Access Compliance Report

Public Rights-of-Way

(Curb Ramps)

| Intersection ID: 11830 | Main Street: E_13TH_ST | Cross Street: N_CALDWELL_ST | Location: W |

| ADA ID: 9DF51958422D | Ramp Type: Perp | Initial Pass/Fail: Fail | Overall Compliance: No |

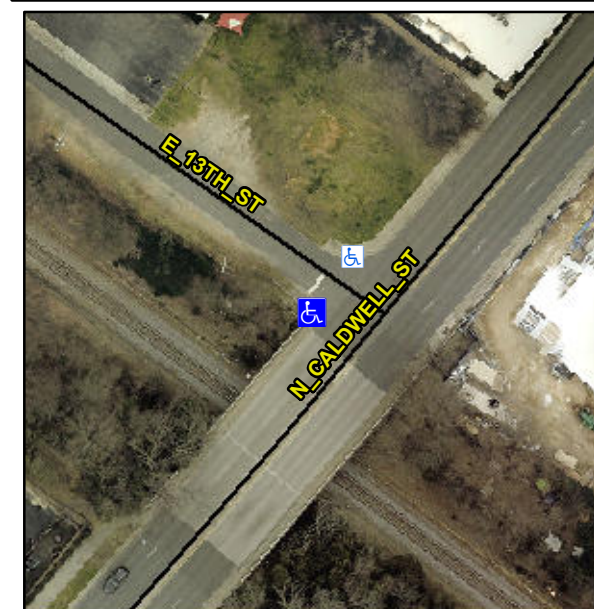
Not Found, R304.5.1, R304.2.2, R304.5.3

| Compliance | Description | Data | Compliance | Description | Data |
|------------|-----------------------|-------|------------|-----------------------------|------|
| N/A | Ramp Length (in) | 56.0 | No | Ramp Slope (%) | 10.0 |
| No | Ramp Width (in) | 42.0 | No | Ramp XSlope (%) | 3.1 |

Remove & Replace Entire Ramp.
